Application Number: DA374-11-00-Mod-7 Applicant: Clean TeQ Sunrise Pty Ltd

Description of Proposed Modification: The proposed modification includes changes to the mining schedule, mine site infrastructure, accommodation camp, and rail siding

Thank you for the opportunity to review the submissions report in relation to the abovementioned project.

Figure 4
Summary of Approved and Modified Accommodation Demand and
Existing Accommodation Supply

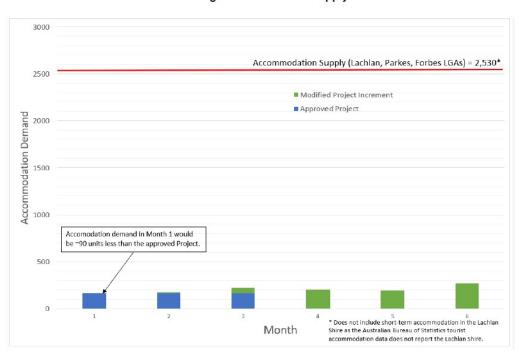
We disagree with the above information. It would appear that the data being used is either inaccurate or out-of-date as the situation on the ground does not match the information outlined above. The availability of short term accommodation and rental accommodation is already stretched in Condobolin and whilst we cannot talk for Parkes it is our understanding that they are in a similar position. There are a number of factors influencing this situation, including Mineral Hill and their operations (47 employees on a 7 x 7 roster), mining exploration projects, building projects, agricultural contractors, etc.

The data should be supported by discussing the on-the-ground information and providing feedback from local accommodation providers and real estate agents. What accommodation is actually available on the ground at the moment and what is the quality of that accommodation. As 90% of the construction workforce is highly skilled it can be expected that SEM will need to provide quality accommodation in order to attract/retain those staff members. A discussion should also be included on the quality of accommodation available during the construction period for the construction camp.
